Subject: Data Response, Set 2A
Hidden Hills Solar Electric Generating System (11-AFC-2)

Hidden Hills Solar Electric Generating System (HHSEGS)

**Data Response, Set 2A
(Response to Data Requests 136 through 143)**

FIGURE DR137-1
Potential Solar Plant Alternative and Parcels
for Inyo County
 Solar Plant Alternative Site, Inyo County
 Hidden Hills Solar Electric Generating System

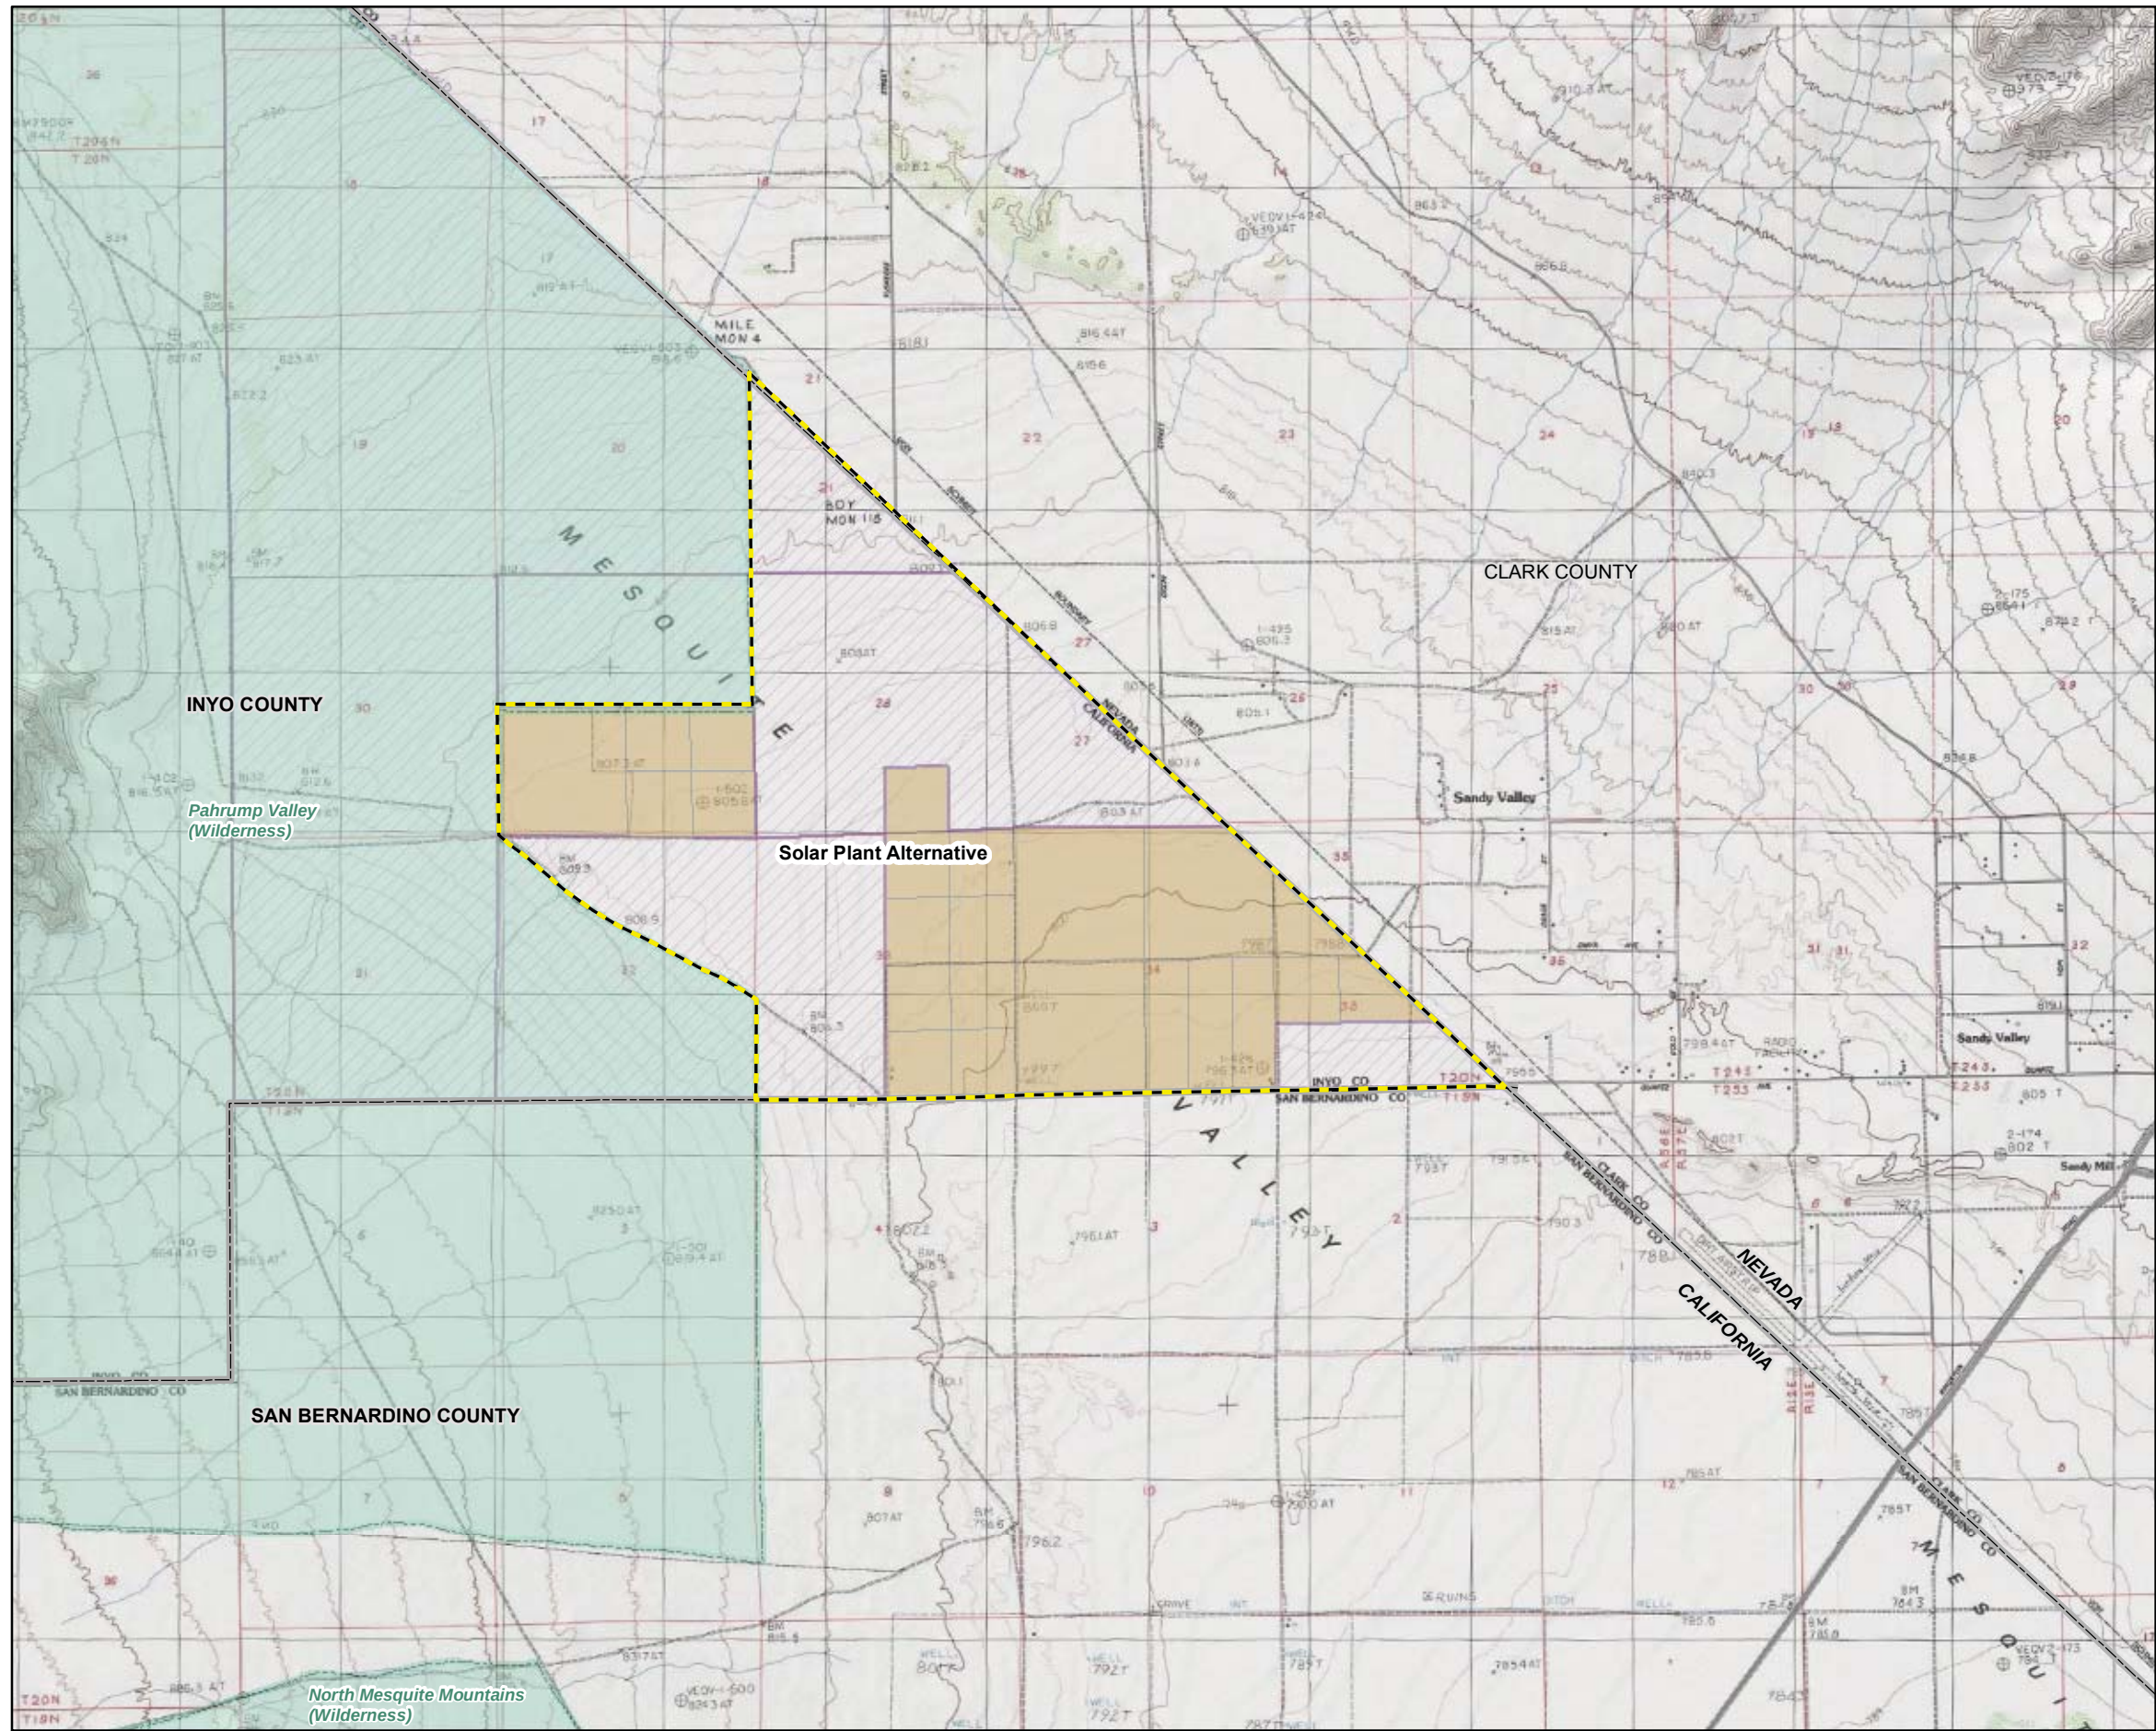
- a. Information on slope and potential available acreage in the area, including potentially available contiguous acreage in the northeast corner of San Bernardino County. Include a map showing a possible project site and footprint. *Provide the shapefile for the figure, including attribute information.* Describe the topography and elevations in the area.

Response: The total potential acreage for a Solar Plant Alternative that is located in Inyo County and not within a wilderness area is 3,119 acres—which is smaller than the HHSEGS project site. A possible project site footprint is shown on Figures DR137-1, titled “Potential Site Alternative and Parcels for Inyo County,” and DR137-2, titled “Potential Site Alternative, Parcels for Inyo County and Elevation Reference.” As shown on Figure DR137-2, this site has relatively flat topography. The requested shape files are included in the enclosed CD, five copies of which are being provided to CEC staff.

FIGURE DR137-3
General Plan and Zoning for Inyo County
Solar Plant Alternative Site, Inyo County
Hidden Hills Solar Electric Generating System

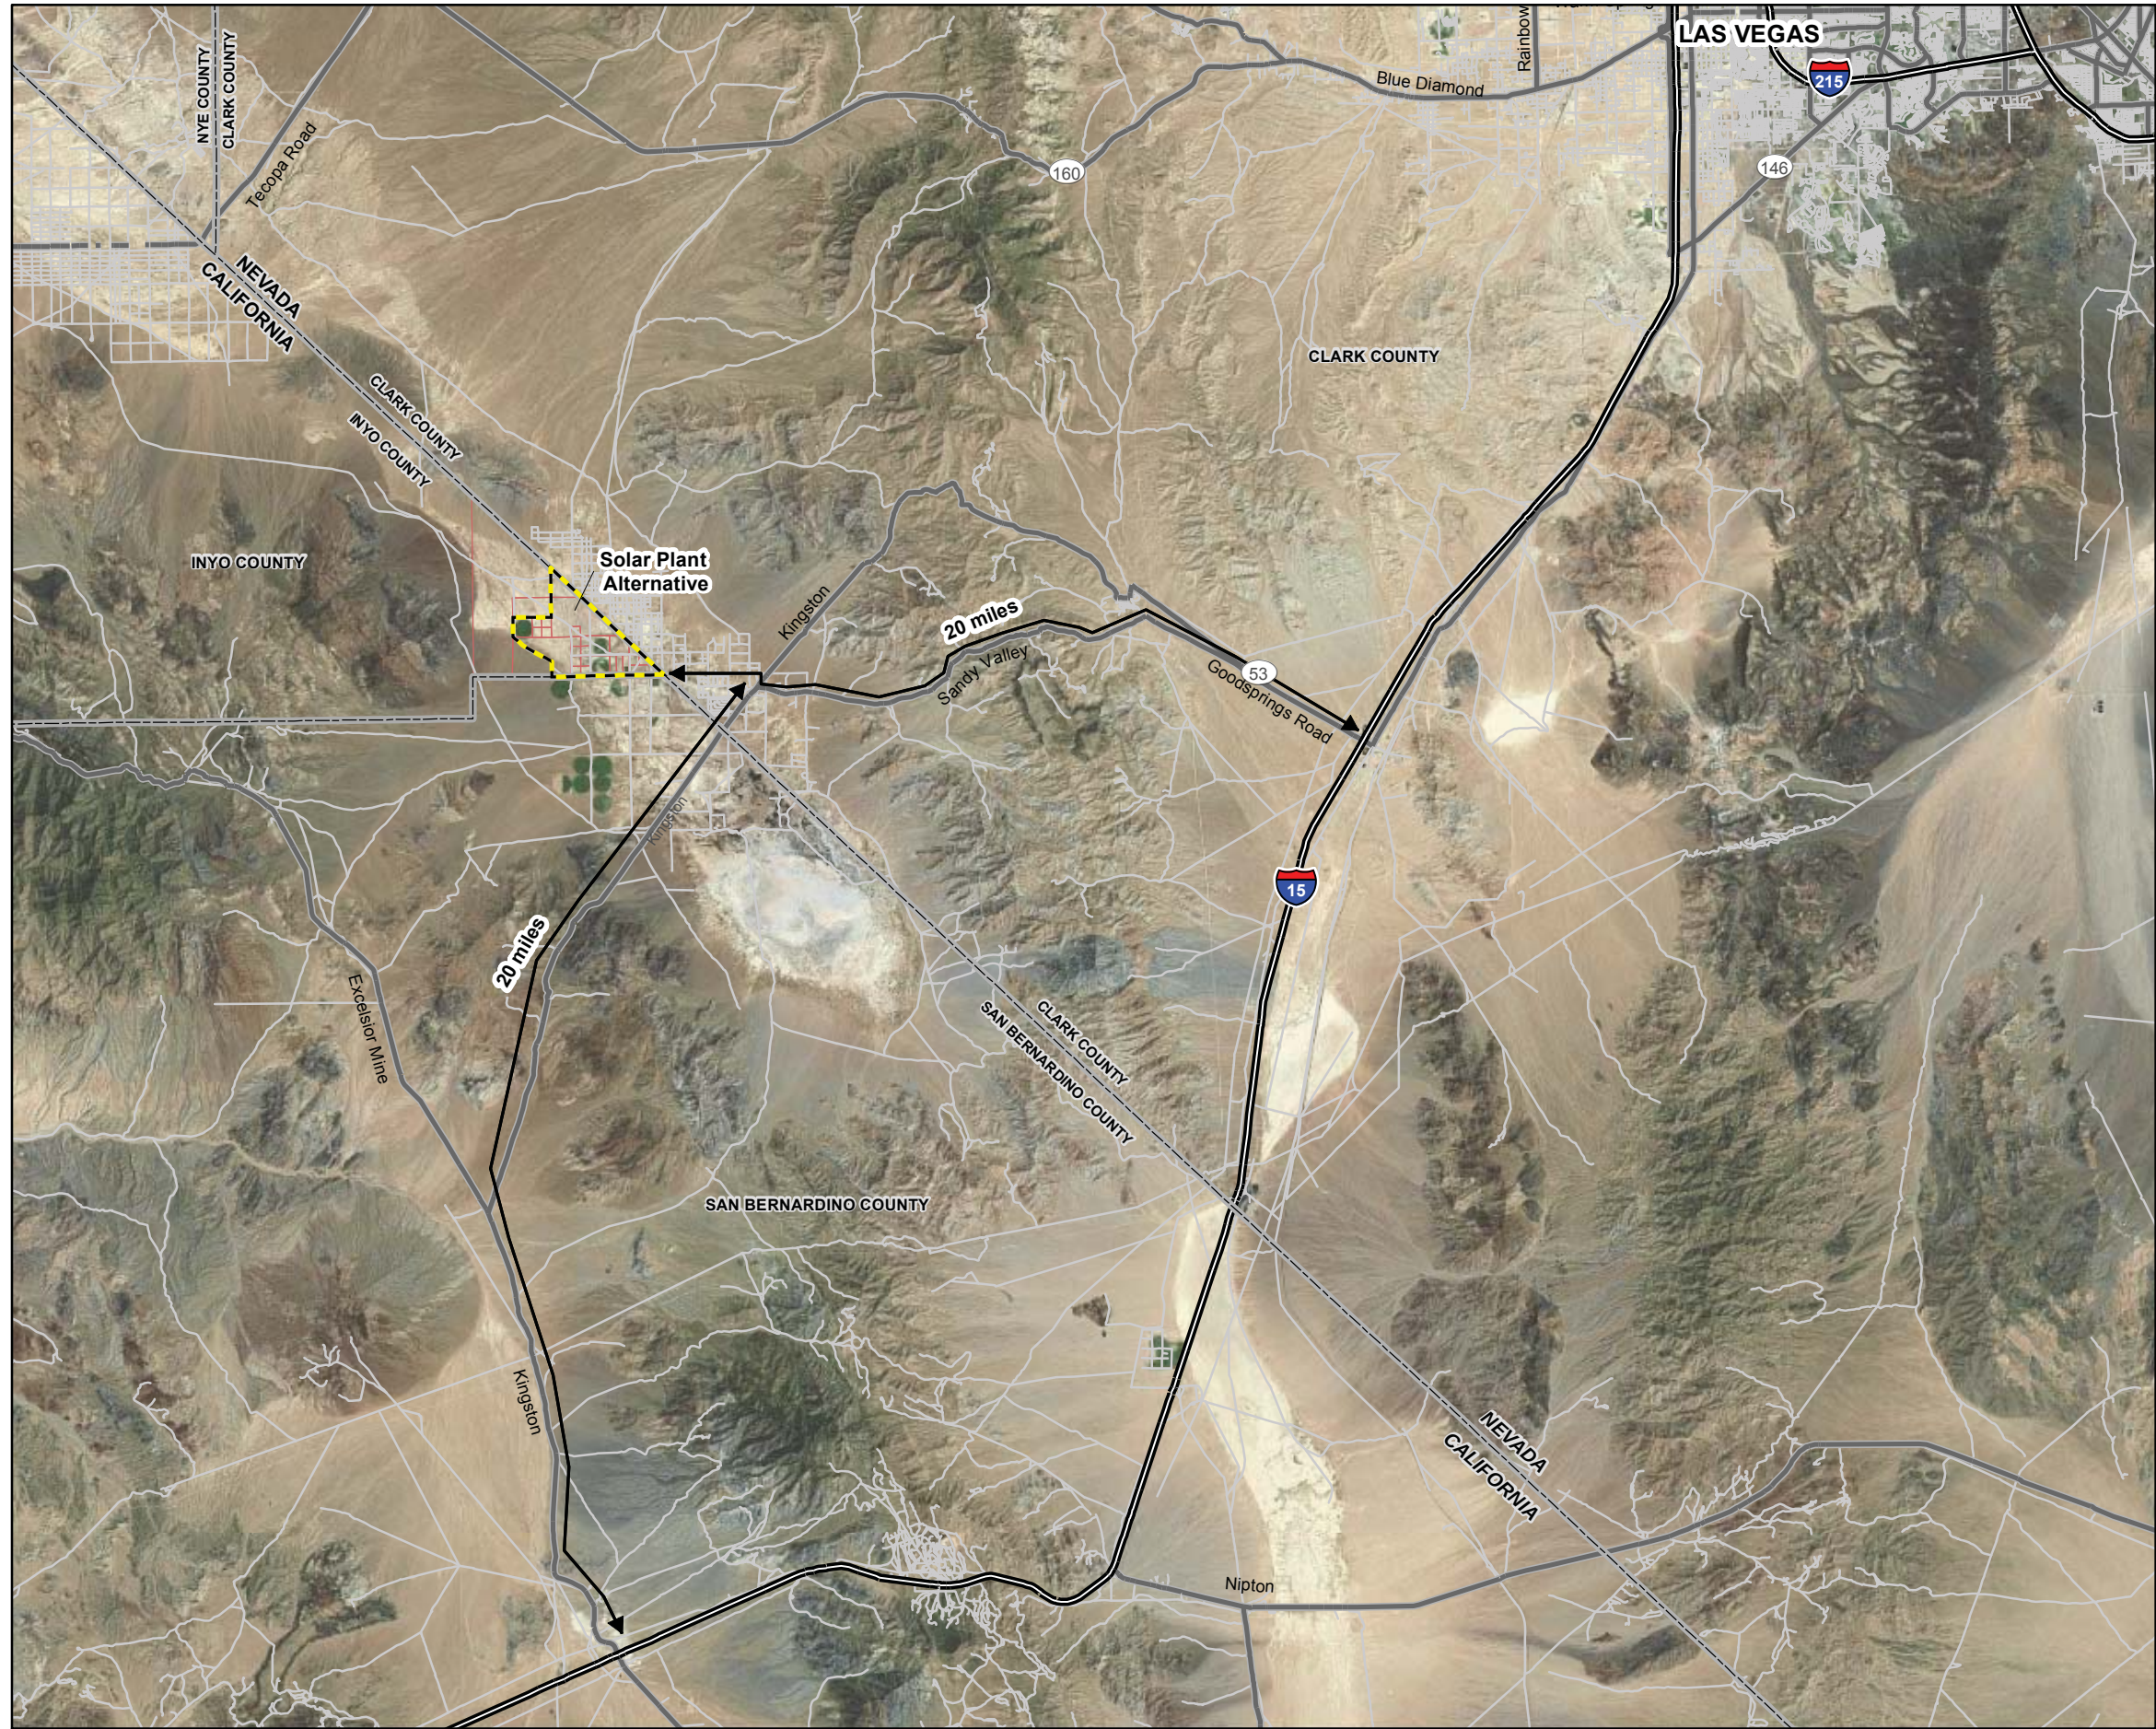
- c. Information on public lands in the area. Describe applicability of the U.S. Bureau of Land Management's plan for the Northern and Eastern Mojave Planning Area to land uses in the area.

- d. Information on Inyo County's general plan designation and zoning for private land in the area. *Please confirm the accuracy of the information provided in the data response on Inyo County's designated land use and zoning district for the area. Include information on San Bernardino County's general plan designation and zoning for private land in the area.*

Response: The HHSEGS site is located entirely on privately held lands and is therefore not subject to conformance with BLM land management policies. For the Solar Plant Alternative site, as shown on Figure DR137-3, the northern portion of the site is in an area that includes federal lands. The portion of the site comprised of federal lands would be subject to the BLM's plan for the Northern and Eastern Mojave Planning Area. Therefore, placing a solar project in the Solar Plant Alternative site would likely require an amendment to that plan.

Response: Figure DR137-3 identifies the general plan and zoning designations for the Solar Plant Alternative. Under the Inyo County General Plan, the Solar Plant Alternative site is designated either as Agriculture or State and Federal Lands. Additionally, Policy LU-1.6 of the Inyo County General Plan provides that the County shall preserve agricultural and related open space uses on private lands and will not designate additional land for rural residential development. The zoning for the Solar Plant Alternative site is mostly Open Space (OS-40).
